# Technical Bulletin

Bulletin No.: TCH-001-022

## Subject: **New Cylinder Head Design Tu-Flo 700 Compressor**

### I. NEW STYLE CYLINDER HEAD

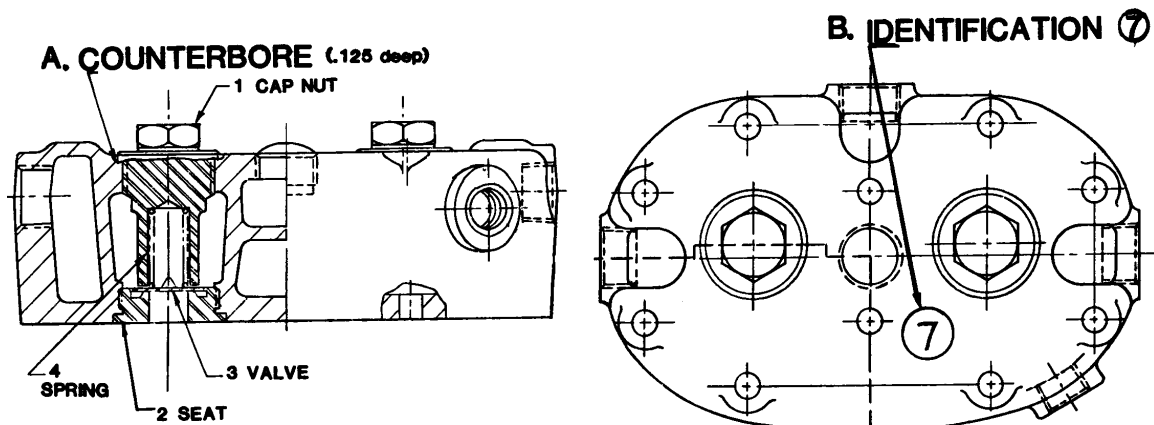
Approximately December 1, 1981 changes will be made in the discharge valve area of all new Tu-Flo 700 Cylinder Heads, which will result in improved compressor performance. Remanufactured Tu-Flo 700 Compressors will be changed on a running basis in the near future.

The new style cylinder head is identified by:

- A. A counterbore (approx. 3/16" deep) of the cylinder head where the cap nut is installed.
- B. A figure "7" with a circle around the figure, stamped or cast into the head surface.

**SERVICE REPLACEMENT PARTS  
(Replace As Required)**

KEY NO.	PC.NO.	DESCRIPTION
1	236215	Cap nut
2	294751 or 237291	Seat
*3	230935	Valve
*4	292375	Spring

\*Items 3 and 4 are included in T/F 700 Maintenance Kit Pc. No. 229417 (for T/F 700 compressors new style cylinder head only.)

**II. OLD STYLE CYLINDER HEAD**

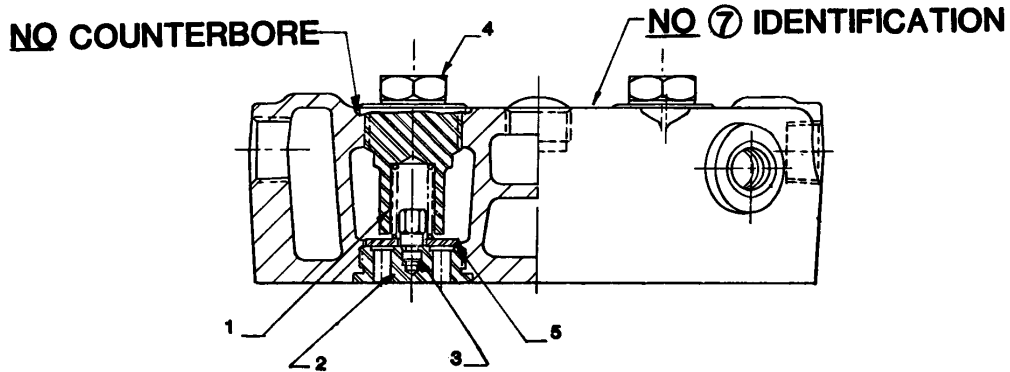
The old style cylinder head can be identified by a shallower 3/32" counterbore and it has no ⑦ identification.

**When service replacement of any of the following parts is required, all of the following parts must be removed and should not be reused in the old style cylinder head.**

When replacing parts, order Pc. No. 102727 Discharge Valve Kit or Pc. No. 289998 Tu-Flo 700 Maintenance Kit.
